Date: November 2, 2022  
To: All Bidders  
Project: West Bay Street Coastal Access Repair Project  
Subject: Addendum #3  
Sent Via: Posted at <https://www.sandcity.org/our-community/advanced-components/rfp-posts-list>

**WEST BAY STREET COASTAL ACCESS REPAIR PROJECT**

DESIGNED BY: MB  
 DATE: 11/01/2022  
 SCALE: 1/8" = 1'-0"  
 PROJECT NO. 20.014  
 DRAWING NO. **L-5.0 OMIT**  
 SHEET 15 OF 15

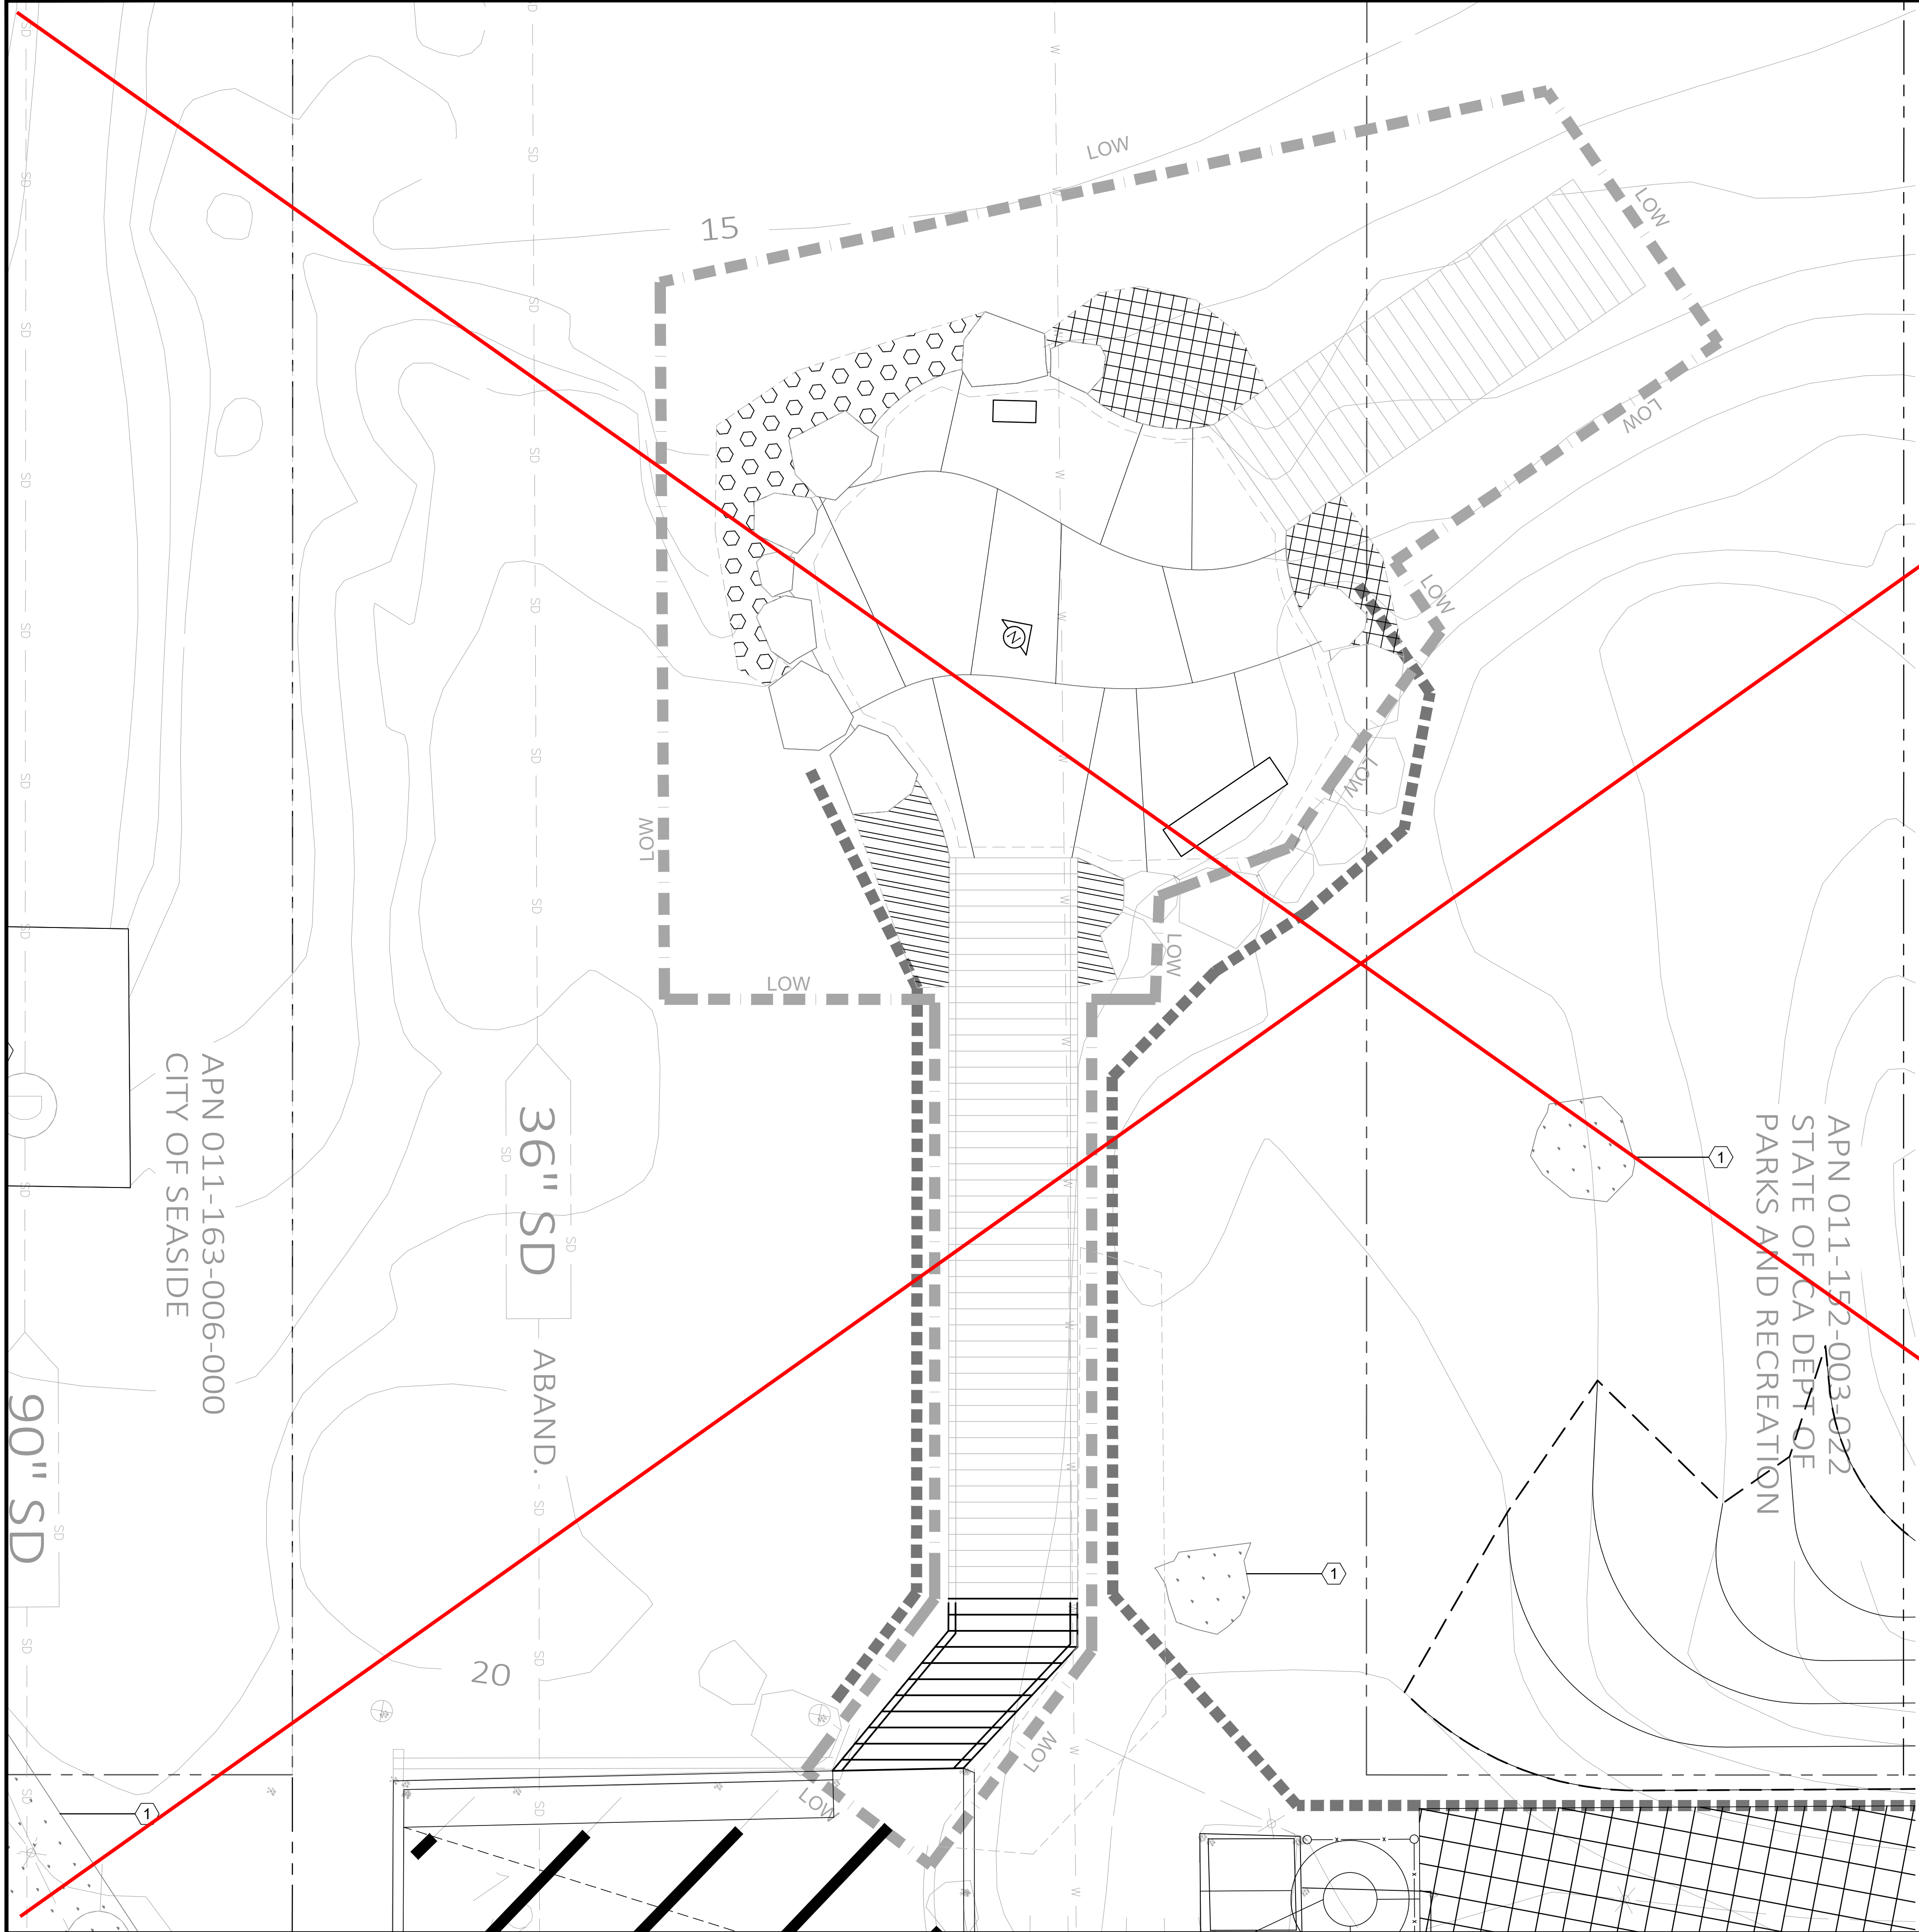
Response: Sheet L-5.0 Planting Plan has been omitted from the landscape plans and this work is no longer a part of the project. Therefore, this spec section and the maintenance and monitoring requirements will no longer apply to this project.

Response: Sheet L-5.0 Planting Plan has been omitted from the landscape plans and this work is no longer a part of the project.

1. **REMOVE** sheet L-5.0 and **REPLACE** with the attached sheet L-5.0 dated 11/1/22.
